Please find below the response to the review formulated for the CDM project "Tangshan Jidong Cement Guye District 8 MW Cement Waste Heat Recovery Project" with the registration number 2731. In case you have any further inquiries please let us know as we kindly assist you.

Response to the CDM Executive Board

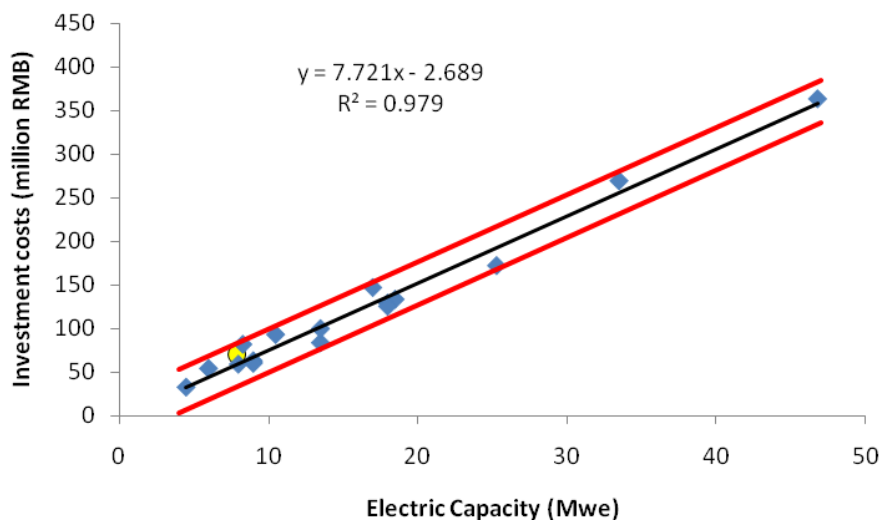
Further clarification is required on how the DOE has validated the suitability of the input values to the investment analysis in particular, the investment costs as per EB 38, para 54(c).

2. Further clarification is required on how the DOE has validated the suitability of the input values to the investment analysis in particular, the investment costs as per EB 38, para 54(c).

Additional to above, we have compared the investment cost of the proposed project in the FSR (i.e. 70,056,600 RMB) to similar registered projects listed in Annex 1. The projects are plotted in a scatter graph with their Investment costs in million RMB on the (y)-axis and the installed

electric capacity in MWe on the (x)-axis. These projects are the basis of the regression analysis. The investment costs were predicted based on the average mean of the Investment cost per total installed capacity and the standard deviation. The regression formula has been defined as:

$$\text{Inv (million RMB)} = 7.721 \text{ Cap (MWe)} - 2.689$$

The correlation coefficient of R^2 of 0.979 indicates a high correlation between the capacity and investment costs. The standard error of 12.49 has been calculated based on the difference between the predicted (theoretical) values and the investment costs listed in the PDDs.

The figure below depicts a regression analysis assuming a linear relationship between the investment costs in RMB and installed capacity in MW for similar cement WHR projects. The proposed project activity (yellow dot) is well within 2 standard errors (indicated with red lines) from the black trend line, which means that the estimated Investment cost of the project activity is similar to the investment cost of similar projects. Hence, we can conclude our “crosscheck”, such as the contracted values, in accordance paragraph 54(c), EB38, that an IRR calculation based on the Investment costs of the FSR which we have conducted is conservative as low investment cost will result in an overestimation of the IRR.
